STATE OF NORTH CAROLINA  
DEPARTMENT OF TRANSPORTATION

SUBJECT: **Supplement to and Revision of Application for Section 404 Nationwide Permit 42 and Section 401 Water Quality Certification** for the proposed Endor Iron Furnace Greenway (Phase I) from Kiwanis Family Park on SR 1009 (Carbonton Road) to Boone Circle (an unopened road), Sanford, Lee County, Division 8. WBS Element 33906.1.1, TIP No. E-4981.

REFERENCE: Application for Section 404 Nationwide Permit 42 and Section 401 Water Quality Certification, dated March 27, 2008.

Site 1

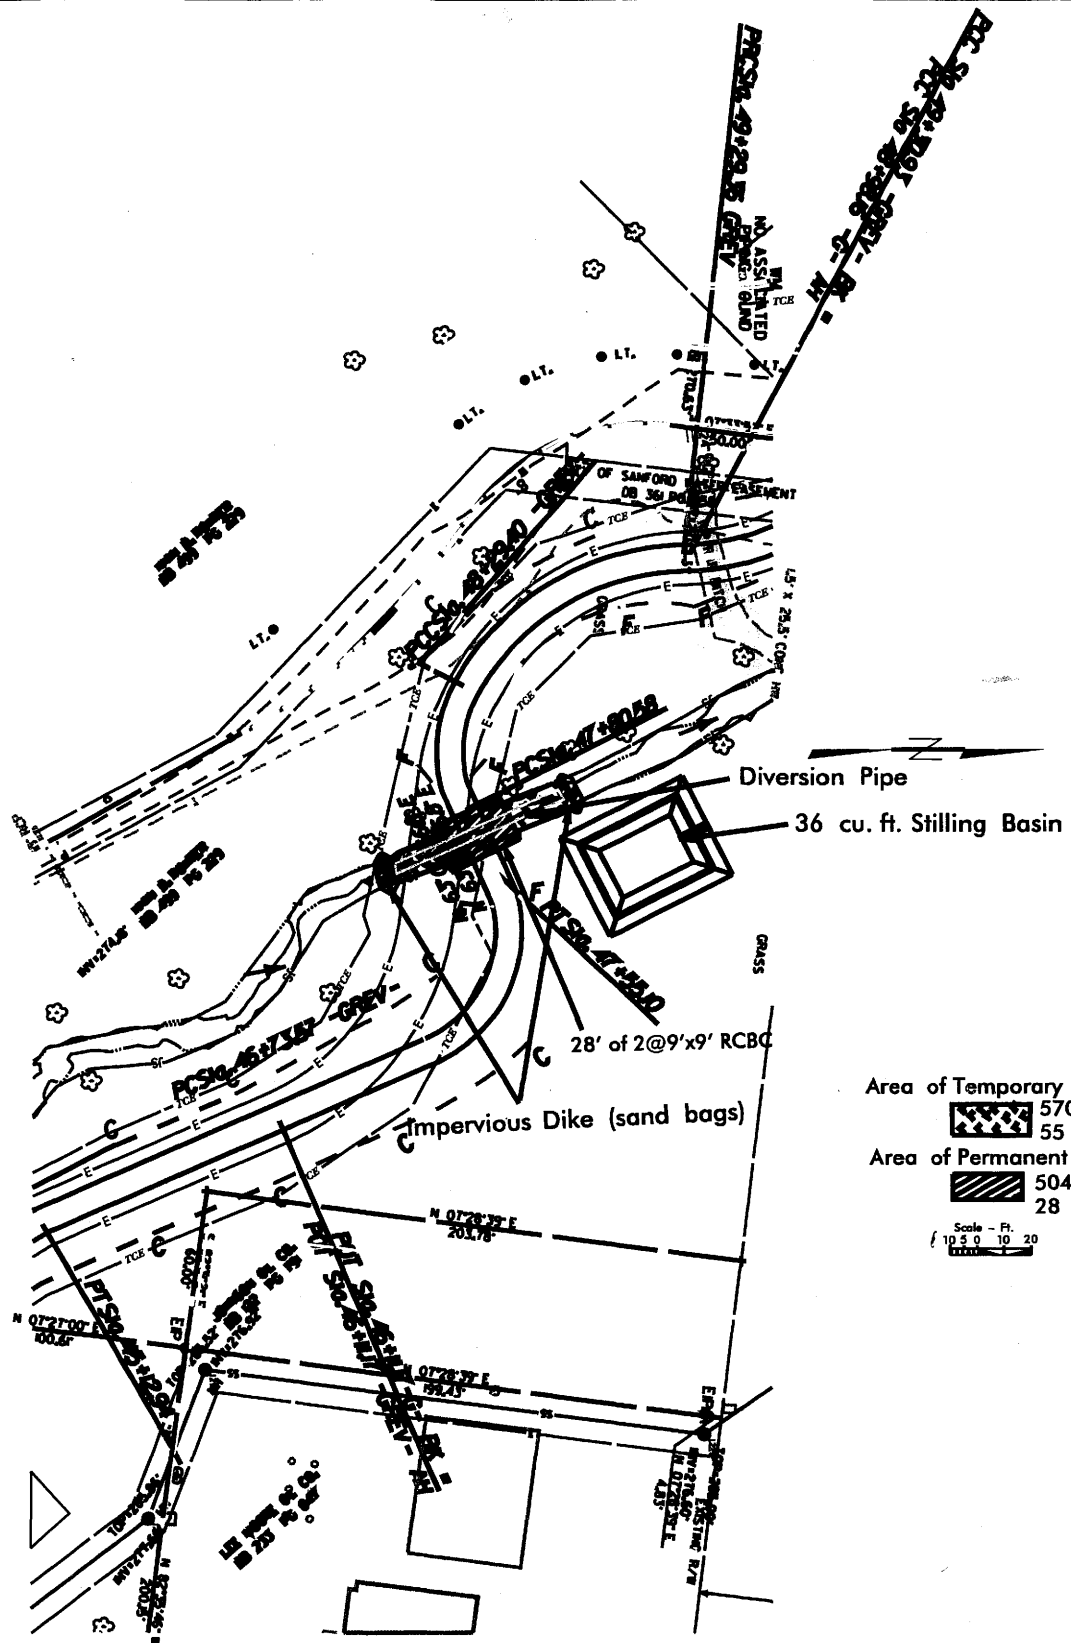
Originally, water was going to be redirected around the area of construction at both RCBC sites using a temporary 5-foot base diversion ditch. However, according to the new construction sequence, impervious sand bag dikes will be built upstream and downstream of where each RCBC will be installed and the area between them will be dewatered using a bypass pump. The water will temporarily be diverted into a stilling basin adjacent to the stream. Once the area is dewatered and prepared, a bypass pipe will be installed between the dikes just prior to culvert construction and use of the bypass pump will be discontinued. Once each culvert is complete, the dikes and bypass pipe will be removed and the stilling basin will be obliterated. This construction method will be used at both sites.

Originally, the construction of the RCBC (STA. 38+05) would have resulted in a temporary stream impact of 124 linear feet to UT 1 to Big Buffalo Creek. However, with the use of the new construction method, a total of 49 linear feet of temporary impacts will now occur. This is a decrease of 75 linear feet.

Area of Temporary Impact  
 633 sq. ft.  
 49 linear feet  
 Area of Permanent Impact  
 336 sq. ft.  
 28 linear feet
